HISTORIC AND DESIGN REVIEW COMMISSION

December 04, 2019

HDRC CASE NO: 2019-692
ADDRESS: 409 QUENTIN DR
LEGAL DESCRIPTION: NCB 8412 BLK 7 LOT E 35 FT OF 7 & W 35 FT OF 8
ZONING: R-6
CITY COUNCIL DIST.: 7
DISTRICT: Monticello Park Historic District
APPLICANT: Amalia Cavazos
OWNER: Amalia Cavazos, Amalia Cavazos
TYPE OF WORK: Install full concrete driveway
APPLICATION RECEIVED: November 08, 2019
60-DAY REVIEW: January 7, 2020
CASE MANAGER: Rachel Rettaliata

The applicant is requesting a Certificate of Appropriateness for approval to install a full concrete driveway to replace an existing two-ribbon driveway.

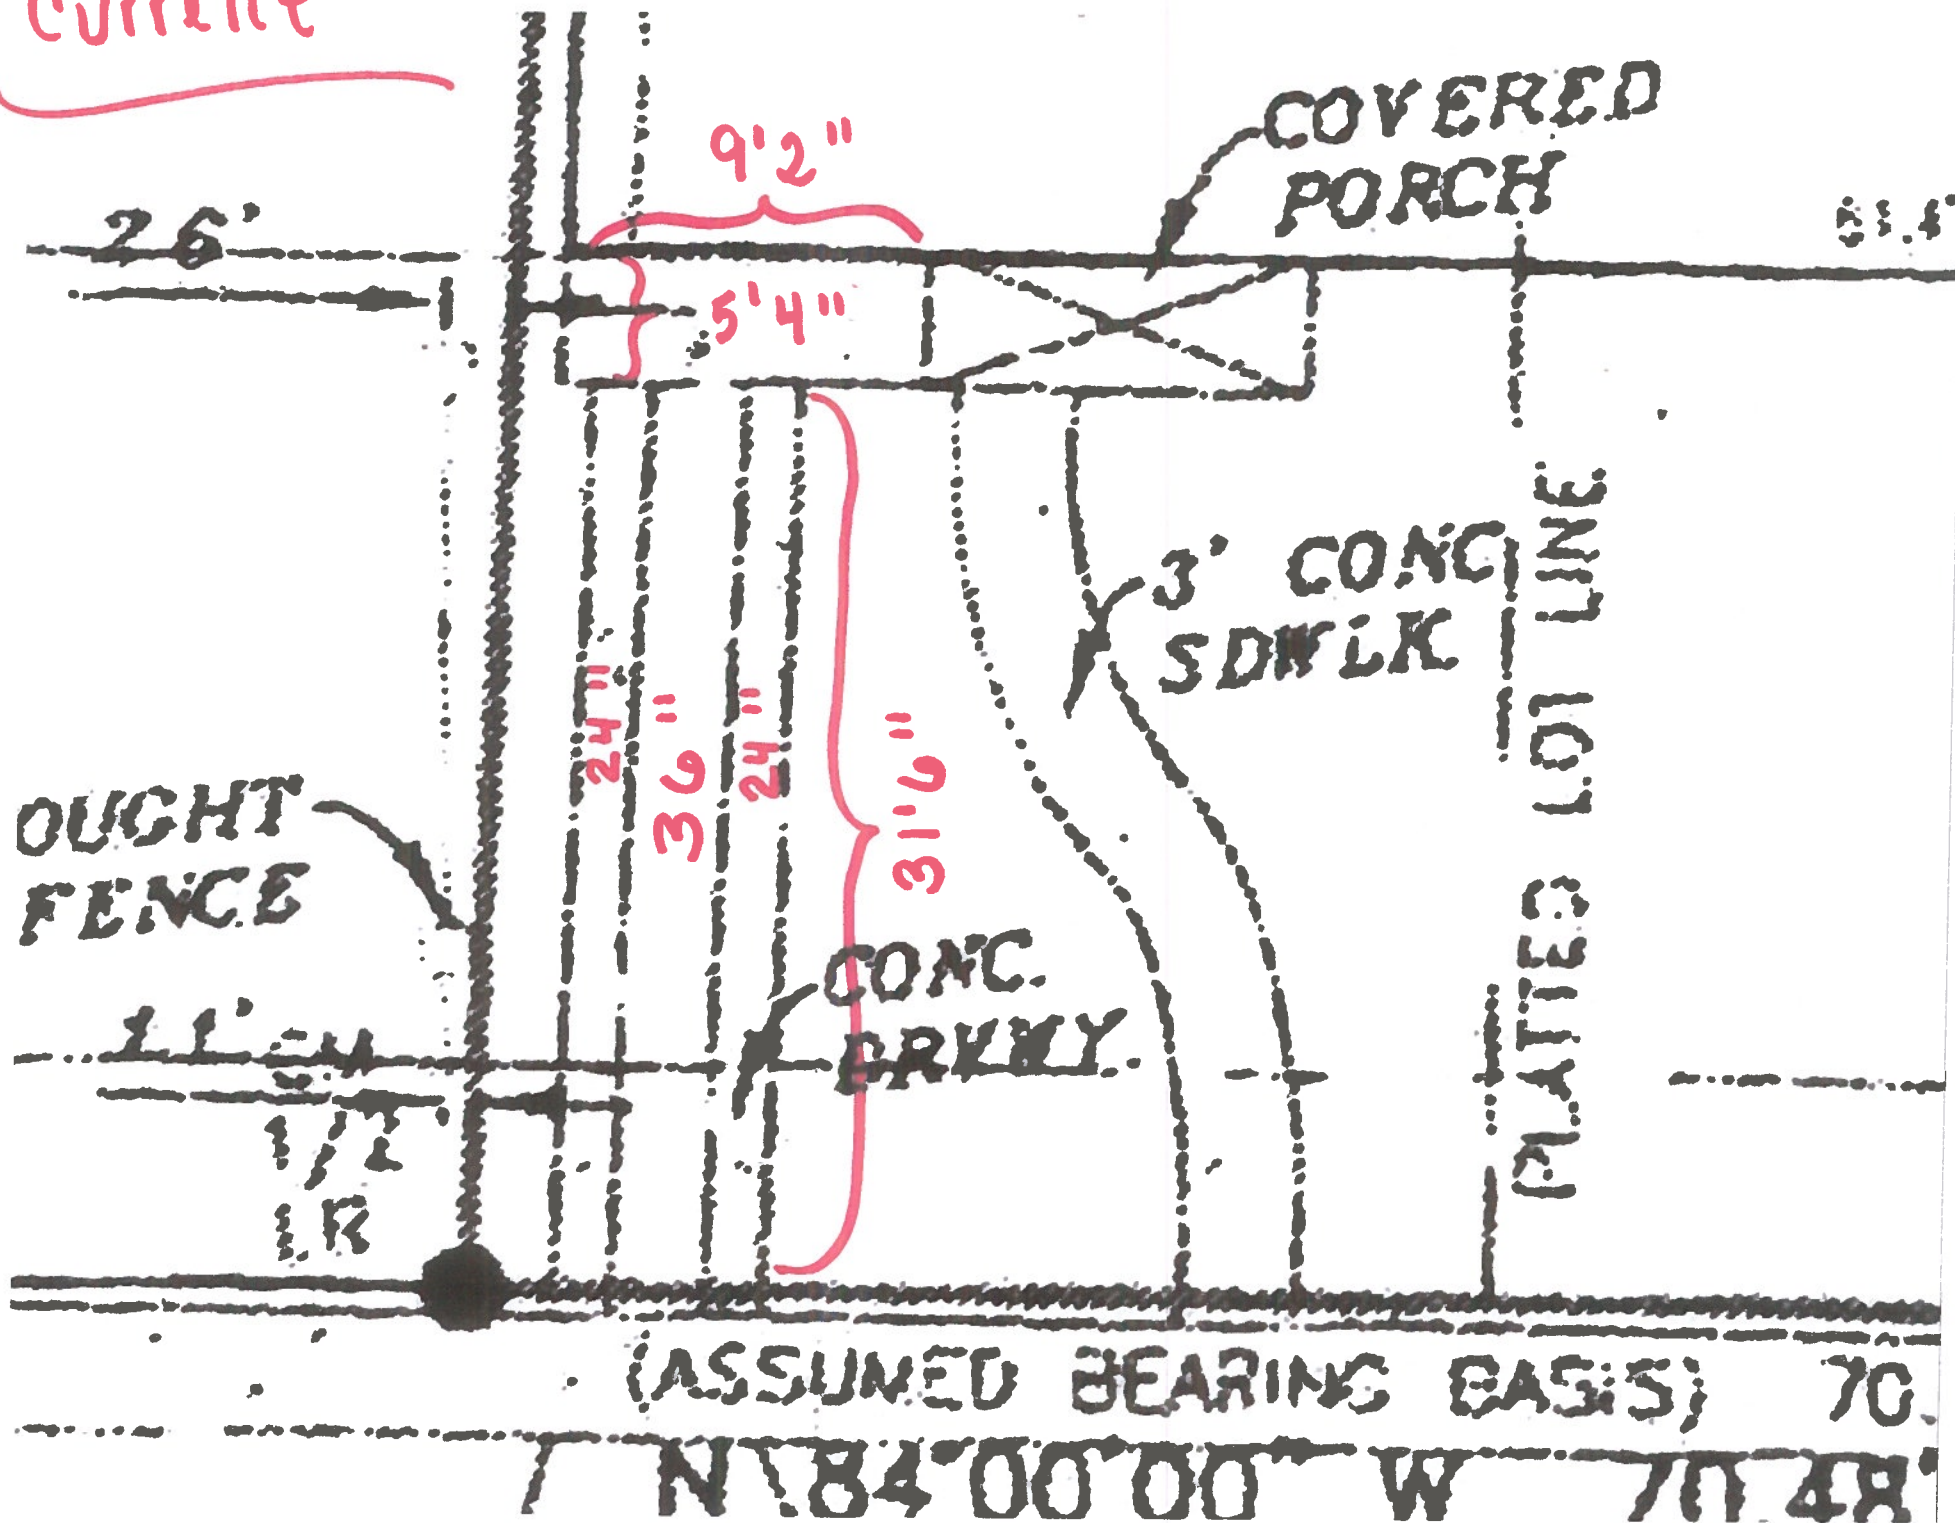
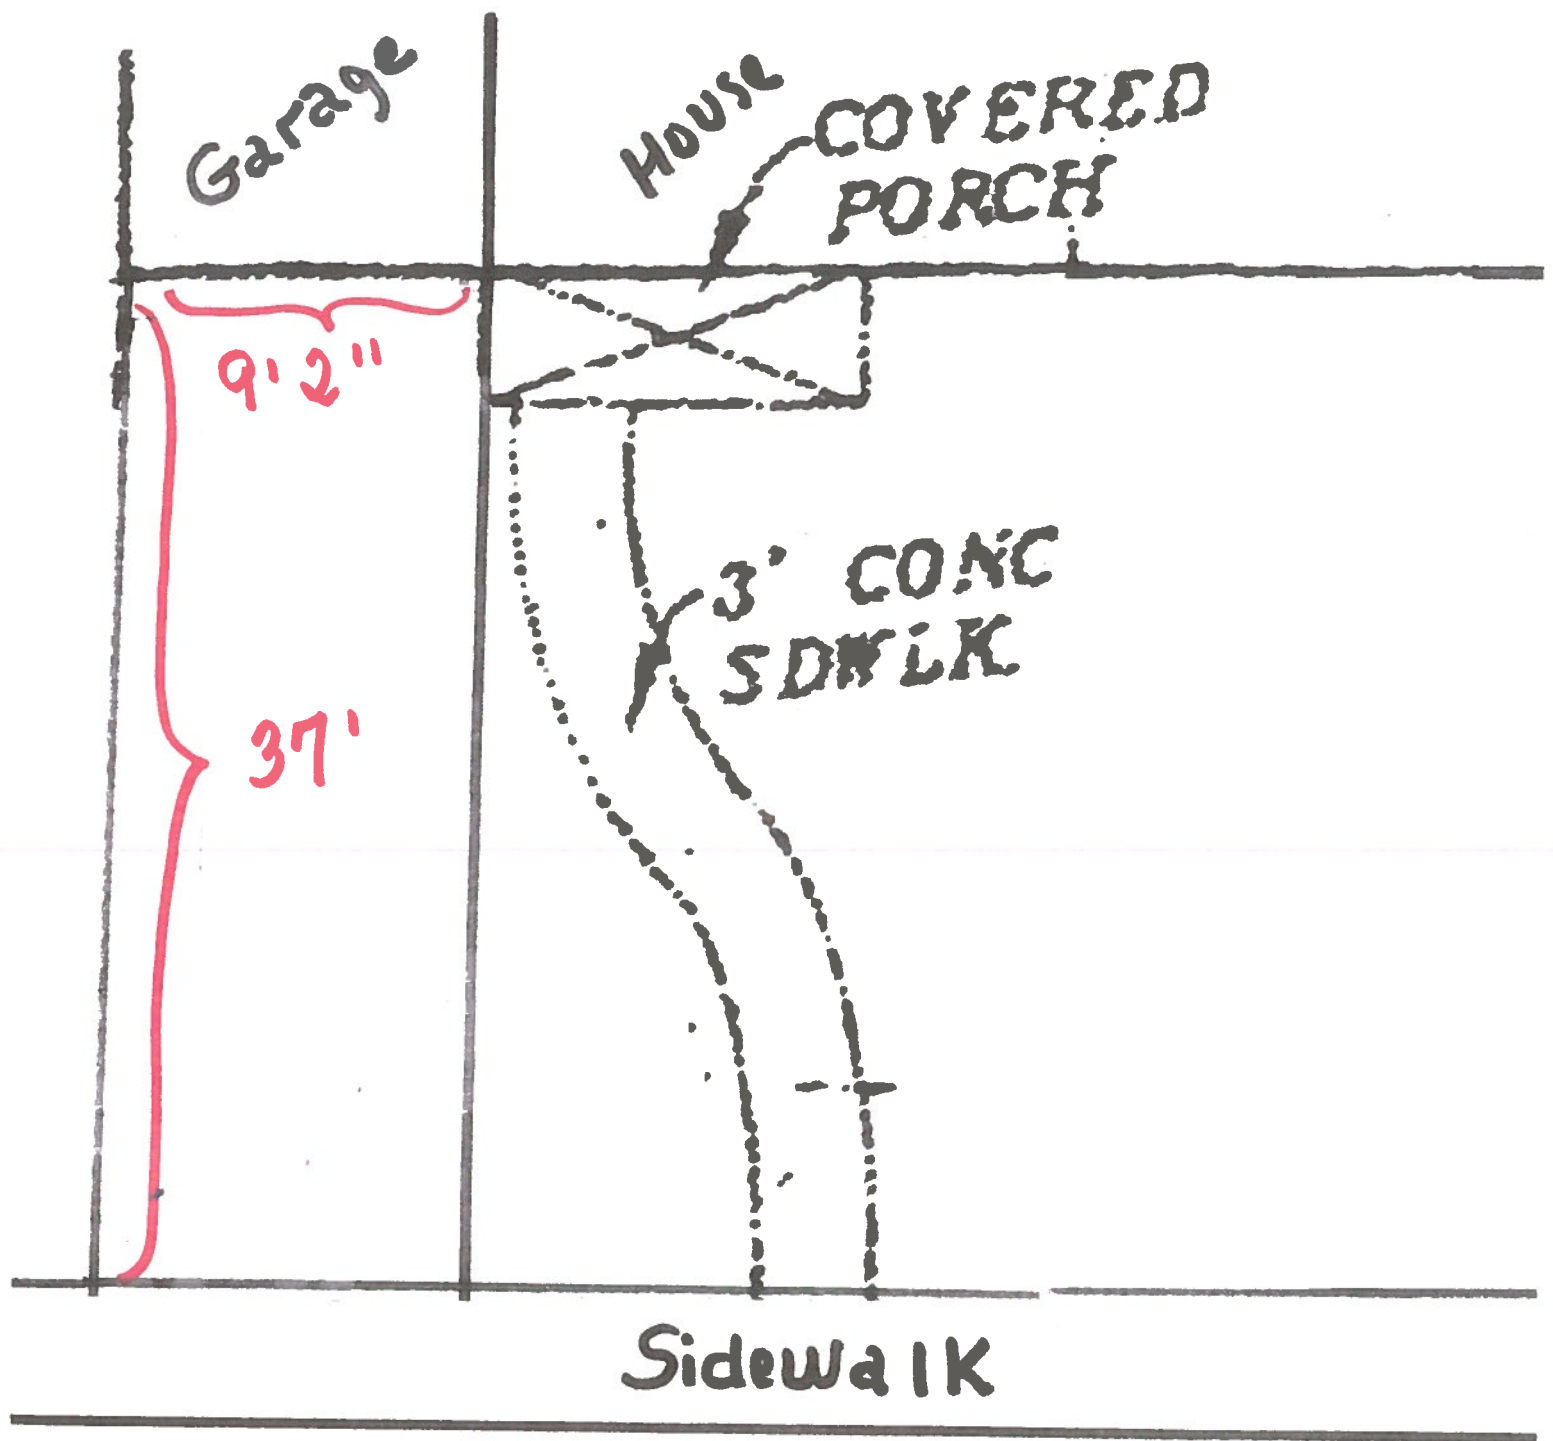
- b. **DRIVEWAY CONFIGURATION** – The applicant has proposed to install a fully concrete slab driveway where a ribbon driveway has historically existed. The Historic Design Guideline 5.B.i. for Site Elements states that historic driveway configurations should be retained and repaired in place. Staff finds the proposal is inconsistent with the Guidelines.

- c. **PERVIOUS MATERIAL** – Guideline 5.B.i. for Site Elements also states that pervious paving surfaces may be considered where replacement is necessary to increase stormwater infiltration. As full concrete driveways exist throughout the neighborhood, staff finds that the use of pervious pavers within the repaired concrete ribbon driveway would be consistent with the Guidelines.

Staff does not recommend approval based on findings a through c. Staff recommends that the applicant install pervious pavers within the repaired concrete ribbon driveway.
